# Road Safety Audit for the Lincoln Memorial Circle

September 2014

A Road Safety Audit (RSA) was performed for the Lincoln Memorial Circle (LMC) from Wednesday, April 30, 2014 through Saturday, May 3, 2014 to provide recommendations for safety improvements.

*Figure 12: Gap between roadway and curb ramp from trail (Photo credit: Norah Ocel) (1)*

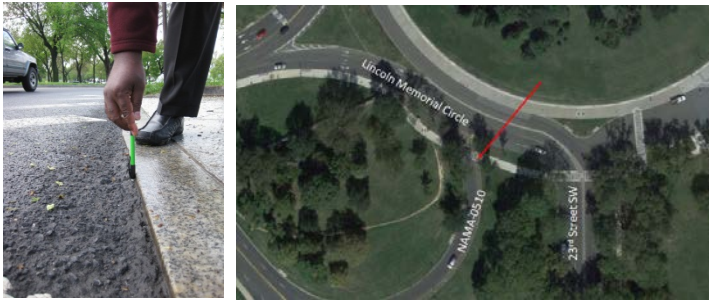
The RSA Team observed a gap between the roadway and trail (Figure 12) as the trail crossed NAMA-0510 (off-ramp from Arlington Memorial Bridge to Ohio Drive) that can be problematic to bicycle tires.

Gap between curb ramp and pavement: There is a gap between the curb ramps and the pavement shown in Figure 35, as demonstrated by Figure 12. During the RSA, a bicyclist stopped to express his concern that this configuration presented a danger to bicyclists, as it can cause ruptured tires. Therefore, the road pavement should be leveled with the crosswalk curb ramp.

*Figure 16: Pedestrian Travel Times (Graphic Credit: Dan Nabors) (1)*

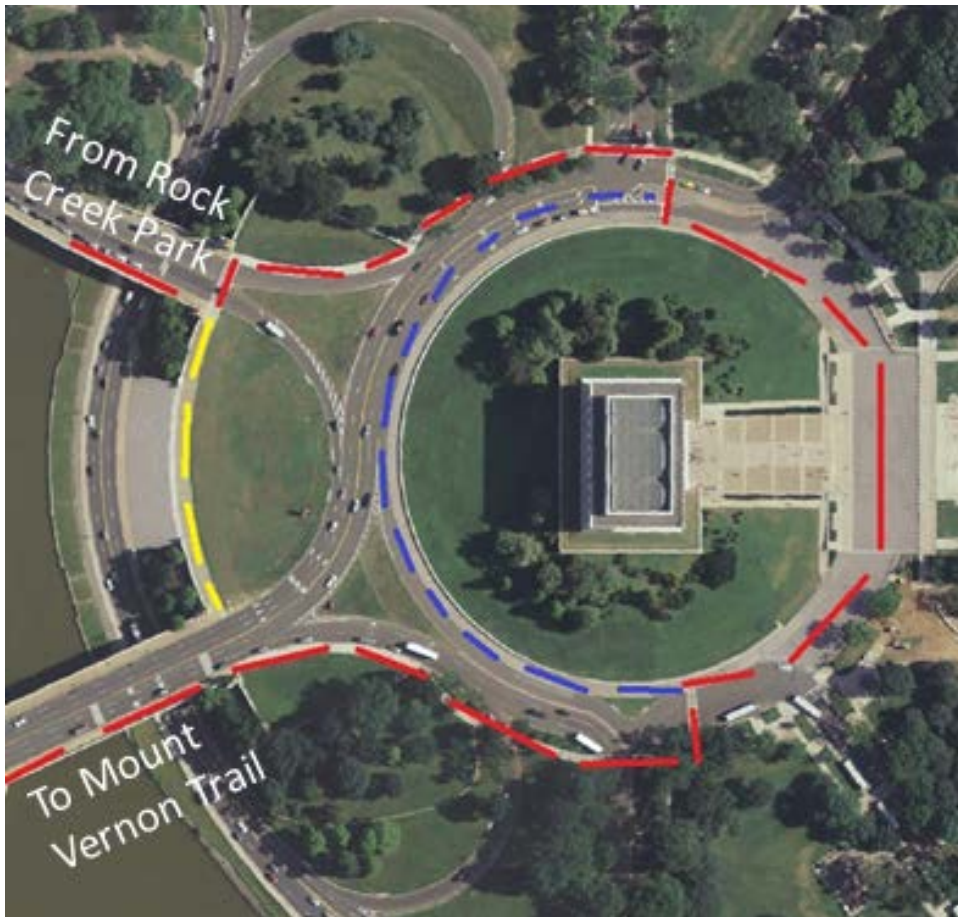
Pedestrian/Bicycling Crossing Options: As mentioned in the Introduction, there are many pedestrians and bicyclists who want to cross at three locations within the LMC (see some example photos in the Appendix); however, the current option (shown in Red in Figure 16) is a circuitous route that increases travel time. (Note: The red path is a distance of 0.55 mi, the blue path is 0.21 mi, and the yellow path is 0.07 mi.)

*Figure 17: Three options for pedestrian/bicyclist crossings (1)*

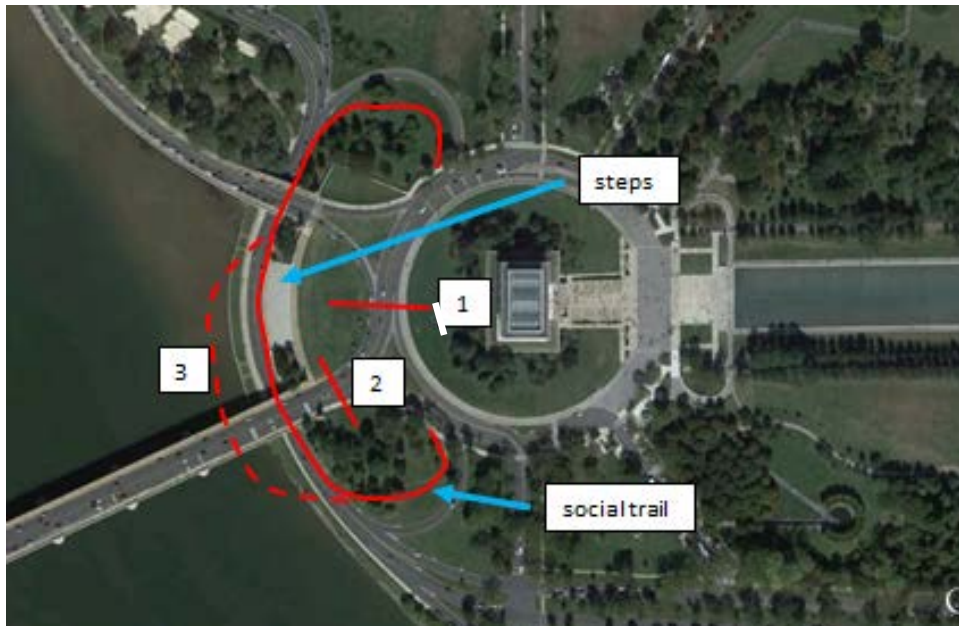
Furthermore, there is little information indicating the designated path. Therefore, the RSA Team discussed three options, each with its own benefits and drawbacks (Figure 17): 1) a tunnel crossing to the Lincoln Memorial's rear side from where the steps originate, 2) a tunnel from the steps to between the social trail and Arlington Memorial Bridge, or 3) a route that makes use of the social trail under Ohio Drive or a floating boardwalk.

Regarding the first option, there are several considerations. First, additional engineering investigations would have to be performed to determine if this solution is feasible. In addition, the rear entrance is used for access during special events at the Lincoln Memorial. Finally, there is a concern with regard to how a tunnel may impact existing infrastructure, like the steps.

Regarding the second option, there are also several considerations. Again, additional engineering investigations would have to be performed to determine the feasibility of a tunnel. It also may affect existing infrastructure like the steps and the wall of the Arlington Memorial Bridge (Figure 18).

*Figure 22: Henry Bacon Drive, Location of Pedestrian Sign (1)*

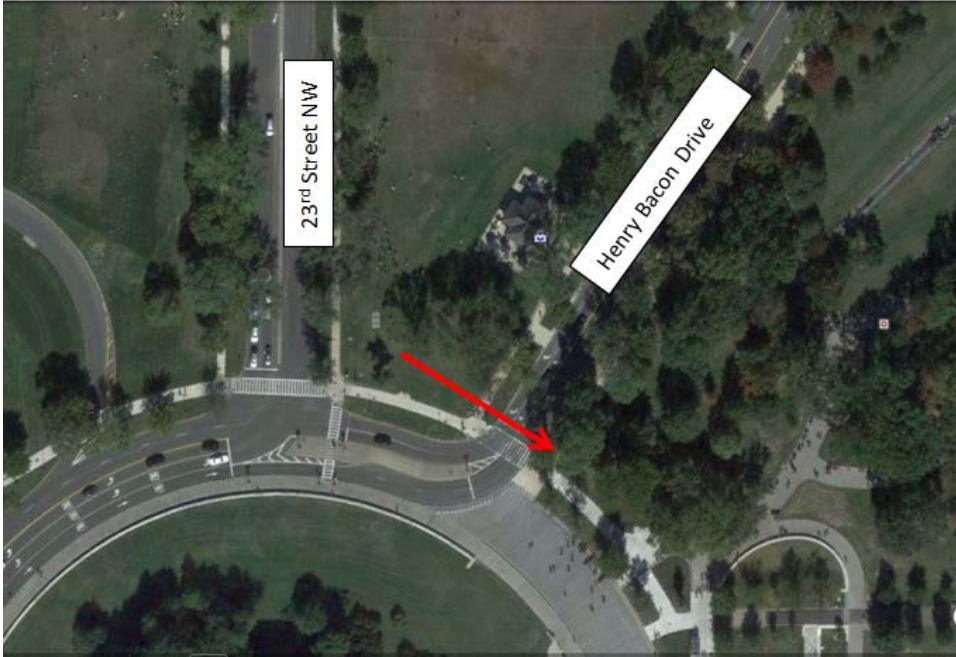
**Pedestrian Sign:** The arrow in Figure 22 shows the approximate location of the pedestrian sign shown in Figure 23. This sign should be removed as the purpose of this sign is unclear.

*Figure 26: 23<sup>rd</sup> Street NW, Existing Curb Ramp*

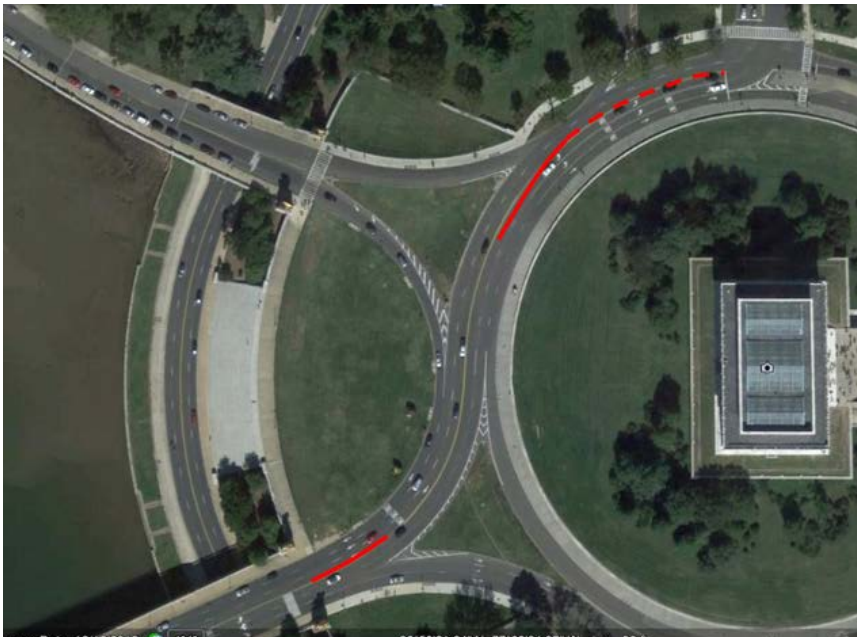
**Curb ramp:** The curb ramps at 23<sup>rd</sup> Street NW are narrow and do not match up well with the painted crosswalks (Figure 26). Pedestrian and bicyclist demand in the area utilizes all of the defined space. Therefore, considerations should be made for providing a curb ramp that spans the same width as the identified crosswalk.

Figure 30: DDOT's R1-6a and W16-7P

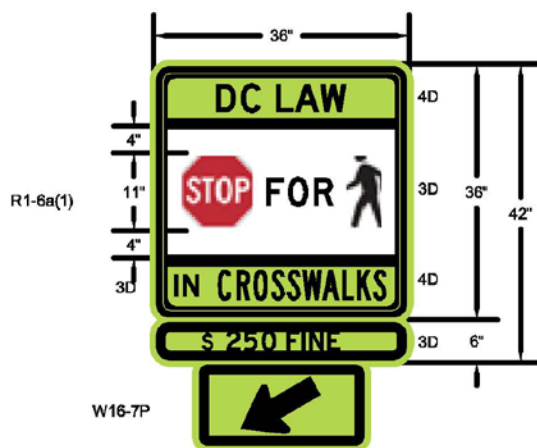
**Pedestrian Crossing Signs:** The type of existing pedestrian crossing warning signs on the approach from NAMA-0509 are not correct. Instead, they should be removed, and replaced with DDOT's R1-6a sign (not including fine information) (Figure 30) in advance of the crossing and at the crossing with DDOT's W16-7P. However, installing R1-6a may be confusing to a driver as a result of the existing close proximity of the yield sign (the R1-6a sign indicates a stop for pedestrians compared with the yield control to enter the circle). Therefore, a previously discussed, further analysis is warranted.

**Pedestrian Signs/U-turn Signs:** The existing pedestrian crosswalk signs for westbound traffic (Figure 33) are not the standard signs for pedestrian crosswalks. They should be replaced with DDOT's R1-6a sign (not including fine information) (Figure 30). In addition, there are no advance pedestrian warning signs for the eastbound approach. Two signs should be installed on the eastbound approach, one on the north side and one on the south side. Furthermore, NPS should consider installing DDOT's R1-6a and W16-7P signs (Figure 30) for both approaches at the crosswalk.

*Figure 45: Independence and 23<sup>rd</sup> Street SW North and South Crossings (1)*

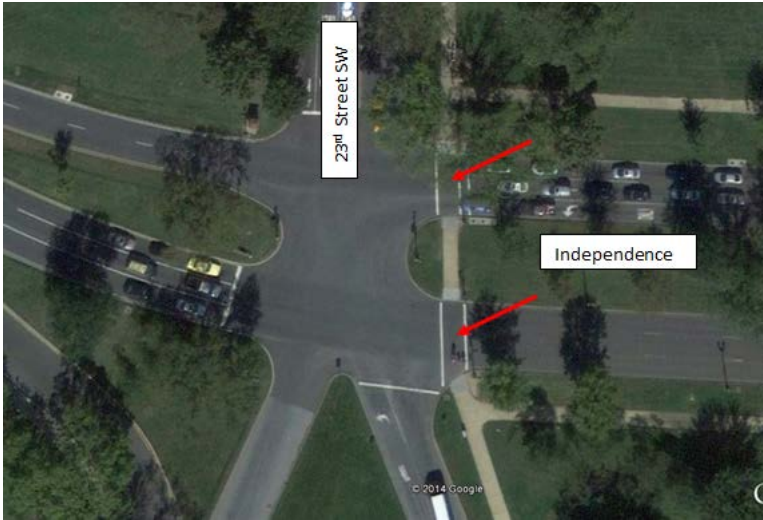
The current timing requires a user to stop at both the southern and northern crossings of Independence (Figure 45), imparting significant delay.

As a result, users disregard the pedestrian crossing indications (Figure 46). Therefore, the team recommends a reconfiguration of the timing for this crosswalk.

*Figure 48: Parkway Drive & Rock Creek Parkway Intersection, Elevation View (Image credit: Dan Nabors)*

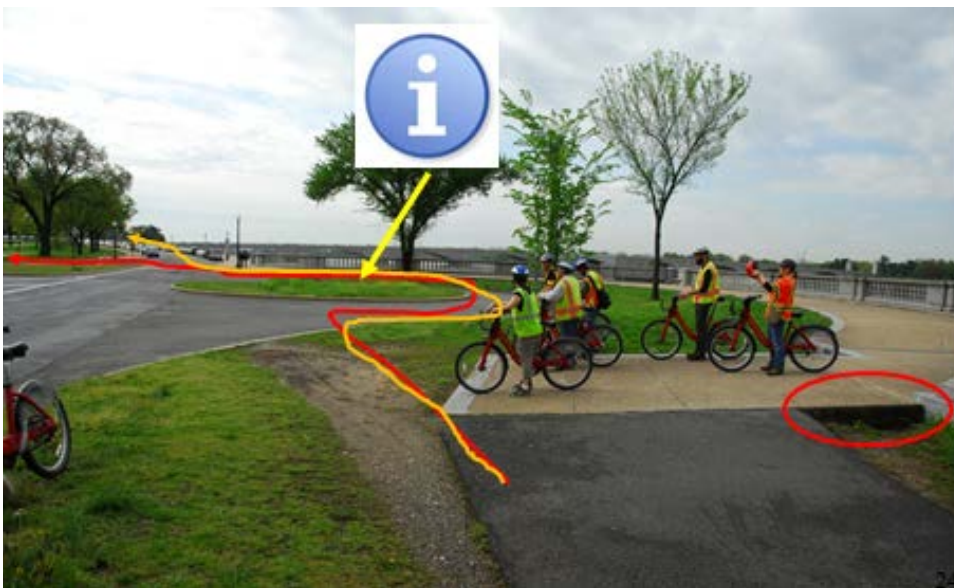
Figure 48 shows the elevation view of this location, pointing out where additional wayfinding information would be useful. In addition, Figure 48 shows a social trail with a drop-off over a curb (following the yellow and red lines). The feasibility of making a smoother transition at this location should be investigated. Finally, Figure 48 shows a drop-off in the right of the photo (indicated by the circle), which could be improved by providing a transition from the asphalt pathway to the concrete pathway.
